THE ROBERT IRSAY COMPANY

RE: Docket No. 99900742/89-01  
Response to Inspection Report

RESPONSE TO NONCONFORMANCE 89-01-02

### RESPONSE TO NONCONFORMANCE 89-01-01

Fig. 14—Application of dimensions to intermittent fillet weld symbols

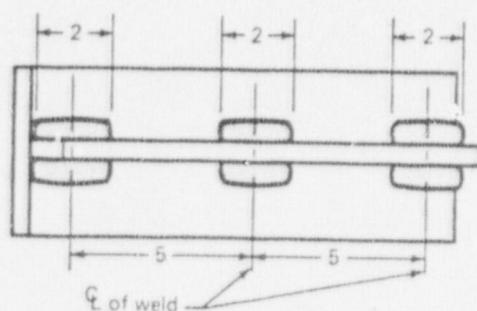
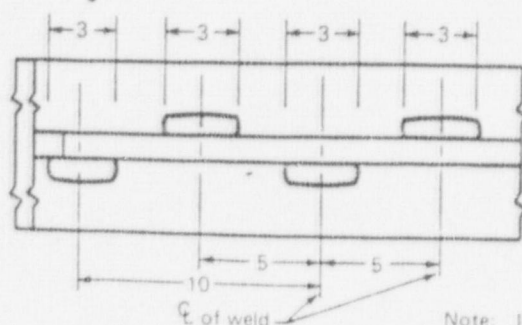
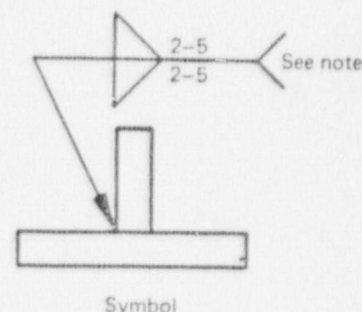
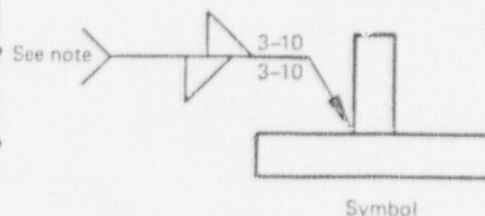
Contrary to Criterion X of Appendix B to 10 CFR 50, and Subsection 11.4 of Section 11 of the RICO Quality Assurance Manual (QAM), inadequate weld inspections were performed on fabricated ductwork in that stitch welds, attaching stiffeners to the ductwork, did not meet the design drawing requirements. The ductwork was documented as acceptable and shipped as meeting the applicable design drawing requirements.

The welds involved were 1/16" intermittent fillet welds 2" in length which were to be staggered on opposite sides of angle stiffeners at intervals of 8" (maximum) per side. Instead, because the weld symbol shown in the Duct Construction Brochure was misinterpreted, the welds were spaced at intervals of 8" but between welds on opposite sides of the stiffeners as opposed to 8" per side as required.

SUBJECT: THE INTREPRETATION AND CORRECT MEANING  
OF THE WELD SYMBOL FOR INTERMITTENT AND  
STAGGERED FILLET WELDS WAS REVIEWED WITH  
SHOP SUPERVISORS, INSPECTORS AND WELDERS.  
COPIES OF AWS A2.4 FIG. 14C WERE REVIEWED  
AND DISTRIBUTED.

SUMMARY OF DETAILS: THE WELDING DETAIL FOR ATTACHING  
RECTANGULAR DUCT STIFFENERS IN ACCORDANCE  
WITH DUCT CONSTRUCTION BROCHURE DETAIL ON  
PAGE DB-10, REV. 1 WAS REVIEWED. ALL WERE  
INSTRUCTED THAT THE CORRECT ~~DETAIL~~ INTREPRETATION  
OF THE DETAIL IS SHOWN IN FIG. 14C OF AWS.  
A2.4
